Exhibit B

License Amendment Request Dated March 31, 1989

Docket No. 50-263 License No. DPR-22

Exhibit B consists of revised pages for the Monticello Nuclear Generating Plant Technical Specifications annotated to show the proposed wording changes:

Figure 3.6.1 Core Beltline Operating Limits Curve Adjustment vs. Fluence

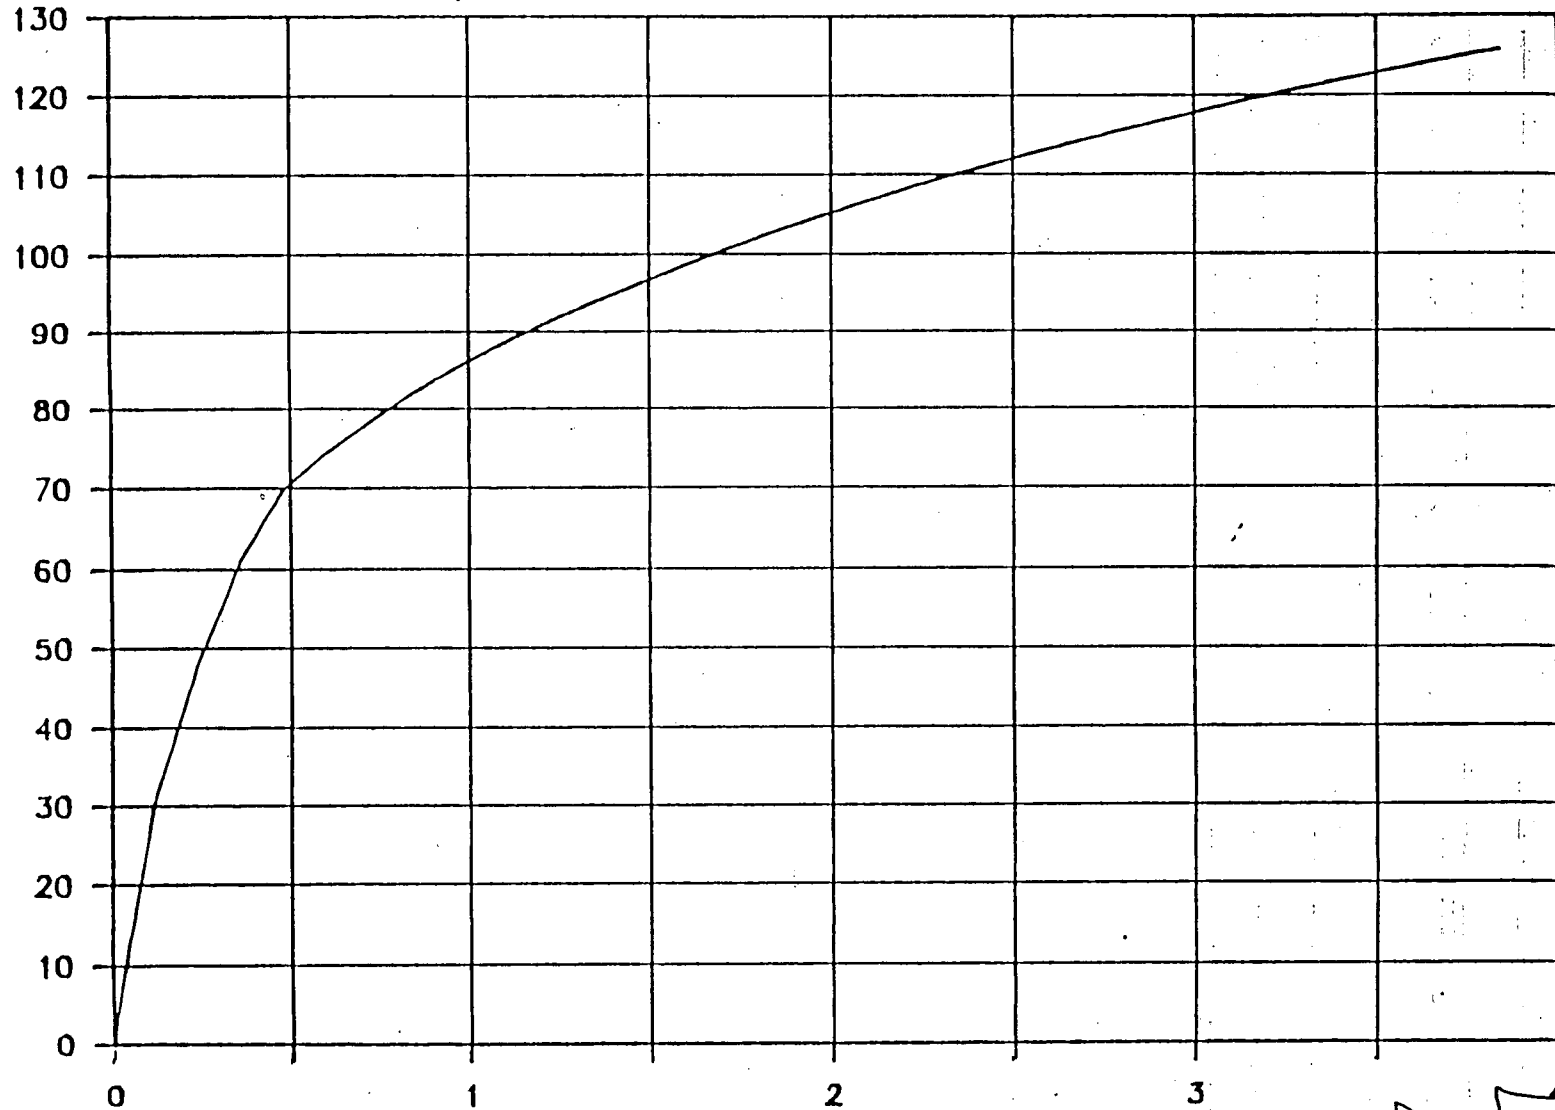
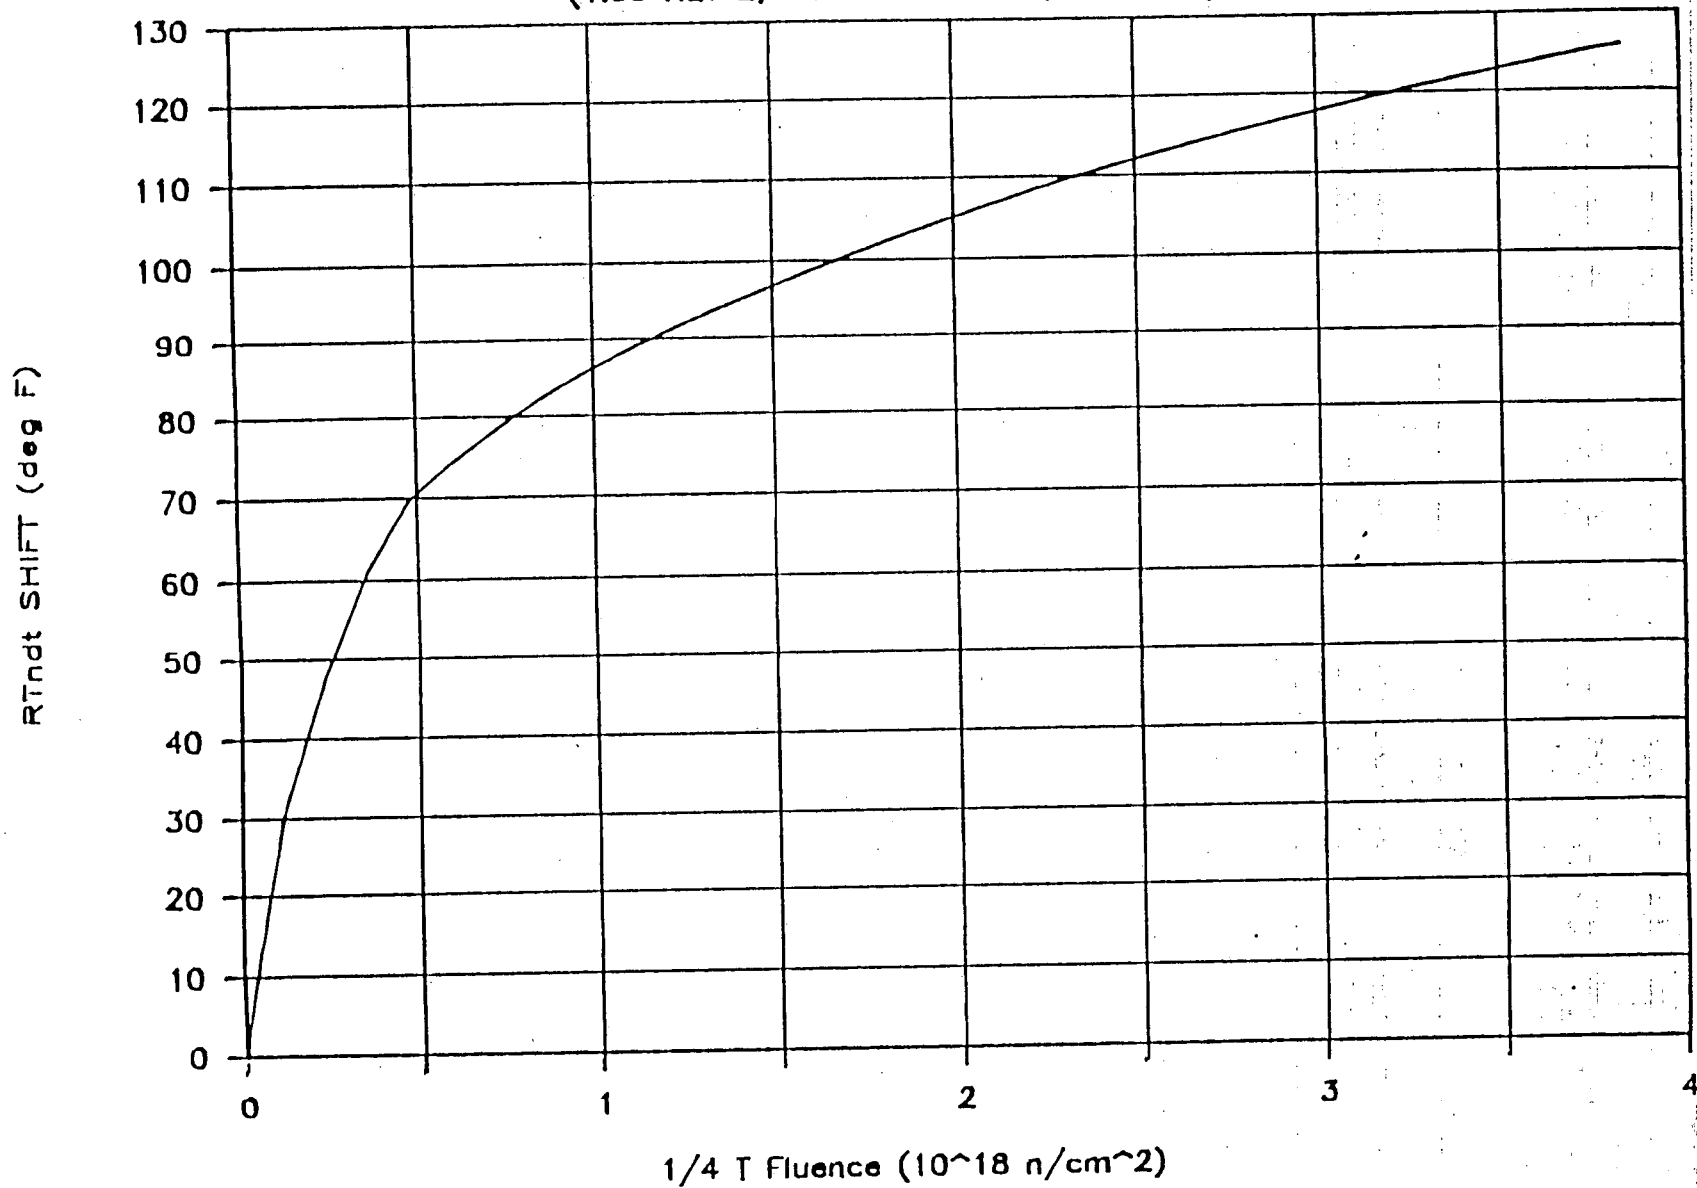
2. Test specimens representing the reactor vessel, base weld, and weld heat affected zone metal shall be installed in the reactor vessel adjacent to the vessel wall at the core mid-plane level. The material sample program shall conform to ASTM E 185-66. Samples shall be withdrawn at one fourth and three fourths service life. Analysis of the first sample shall include a quantitative determination of the material chemistries. (Note: Analysis of the first sample has been completed. The Figure 3.6.1 core beltline temperature adjustment curve reflects the chemistry data obtained).

The relationship of predicted adjustment of reference temperature versus fluence and the copper and nickel content of the core beltline materials give in regulatory Guide 1.99, Revision 2, was used to define the core beltline temperature adjustment versus fluence shown on Figure 3.6.1.

Figure 3.6.2 Minimum Temperature vs. Pressure for Pressure Tests

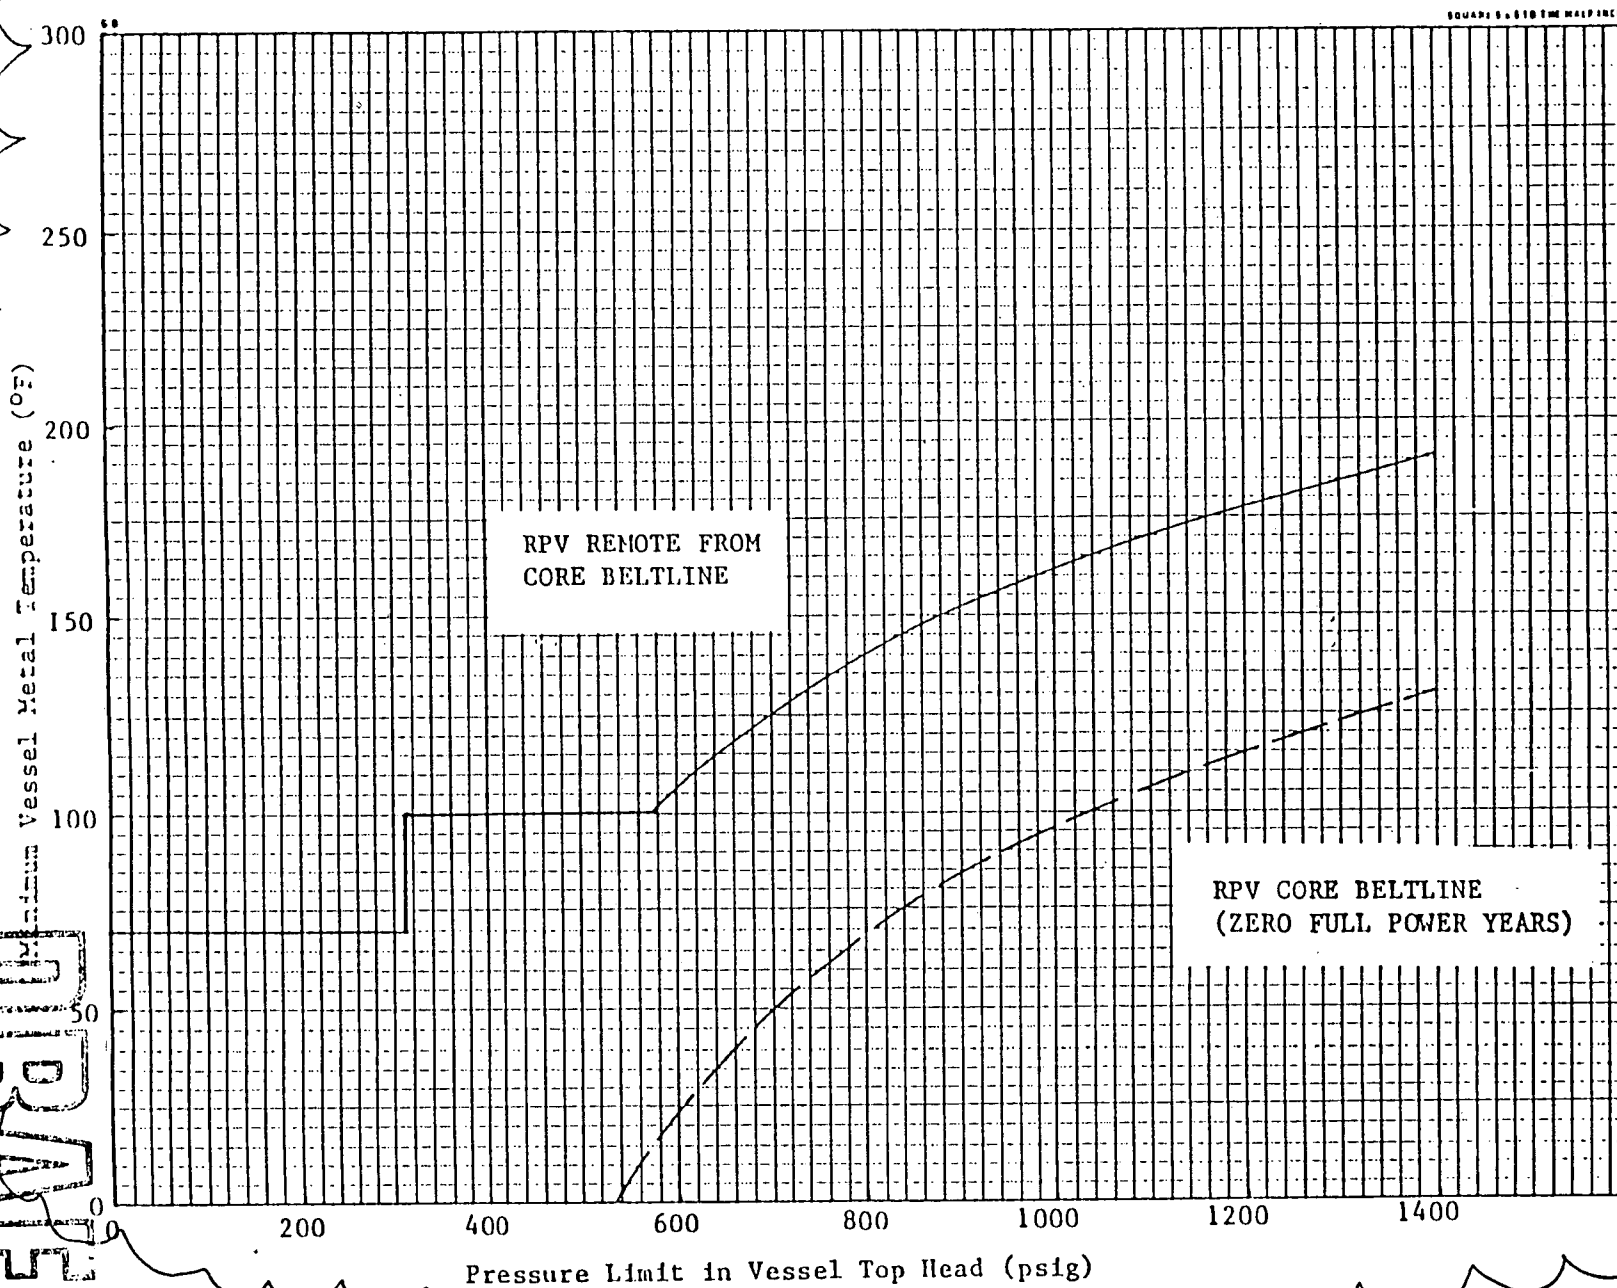
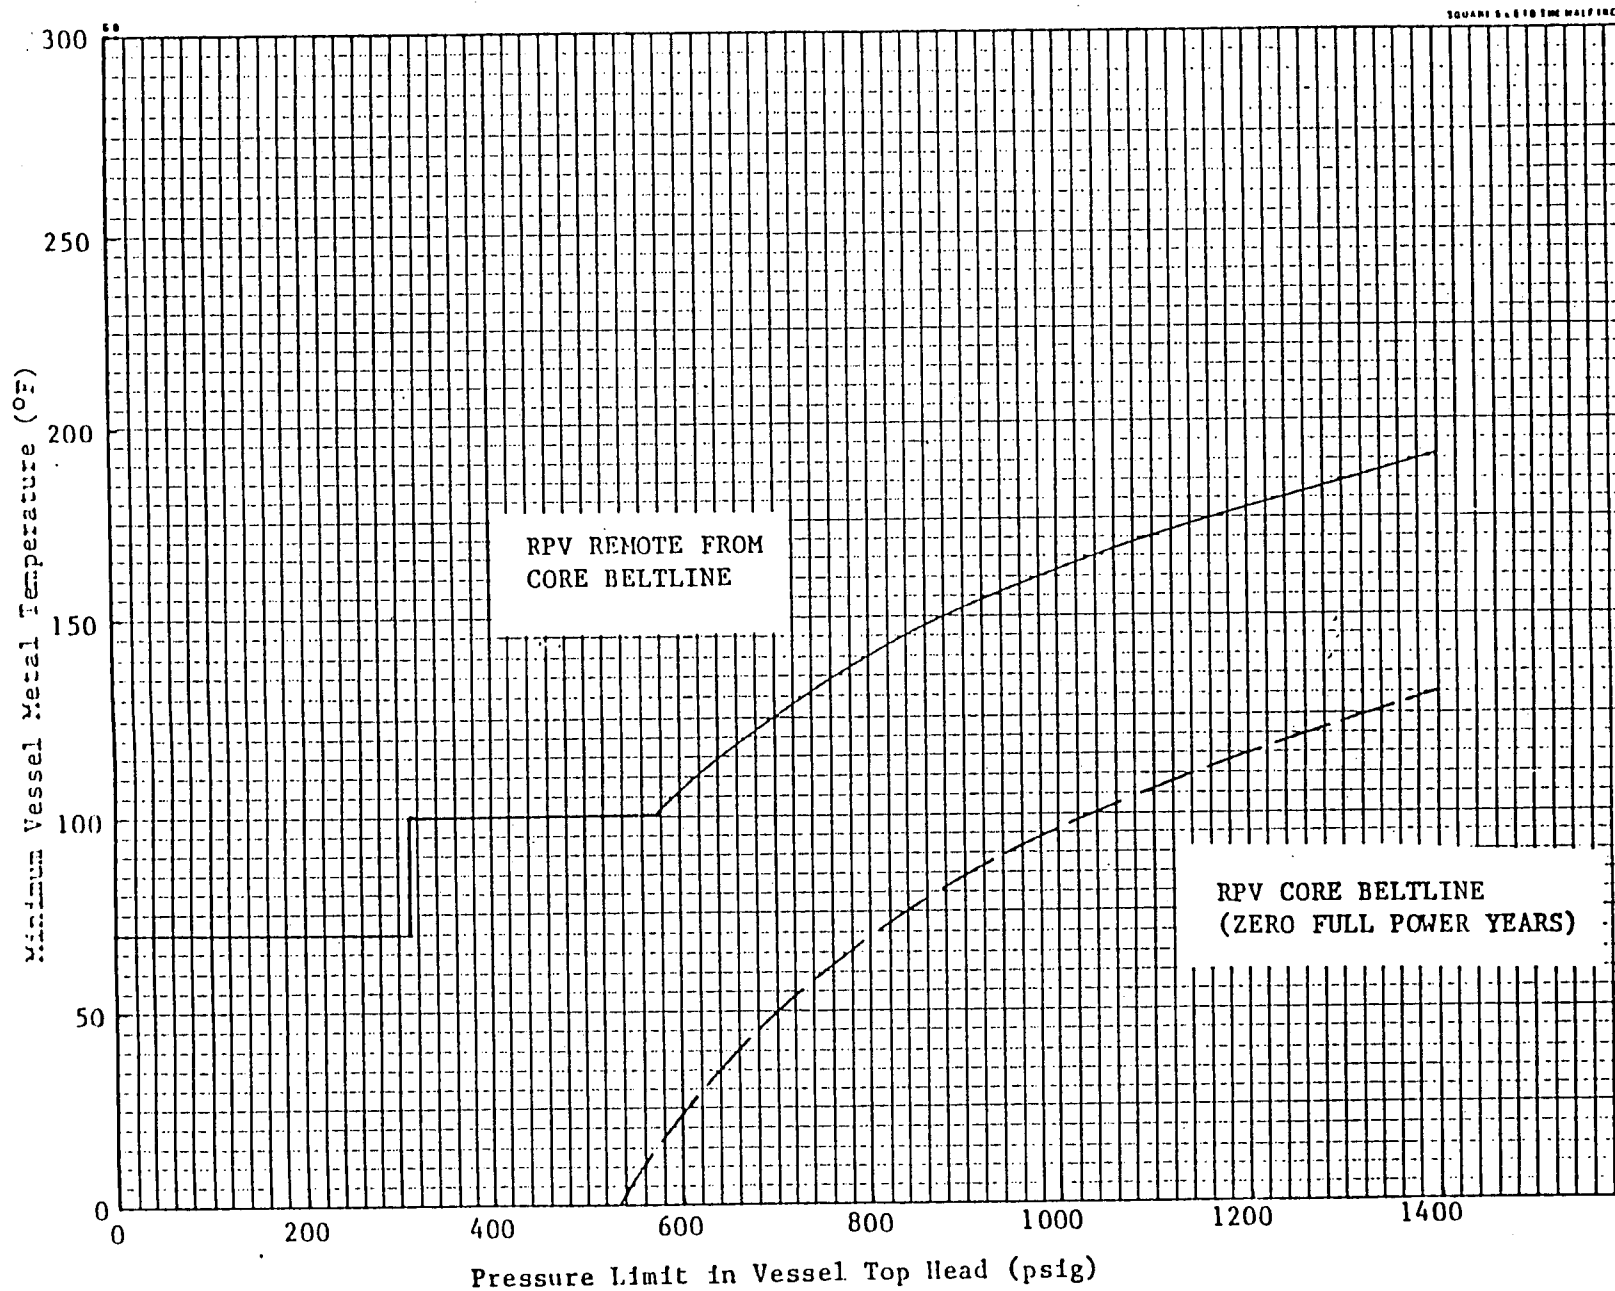
1. During in-service hydrostatic or leak testing, the reactor vessel shell temperatures specified in 4.6.B.1, except for the reactor vessel bottom head, shall be at or above the temperatures shown on the two curves of Figure 3.6.2, where the dashed curve, "RPV Core Beltline," is increased by the core beltline temperature adjustment from Figure 3.6.1. The reactor vessel bottom head temperature shall be at or above the temperatures shown on the solid curve of Figure 3.6.2, "RPV Remote from Core Beltline," with no adjustment from Figure 3.6.1.
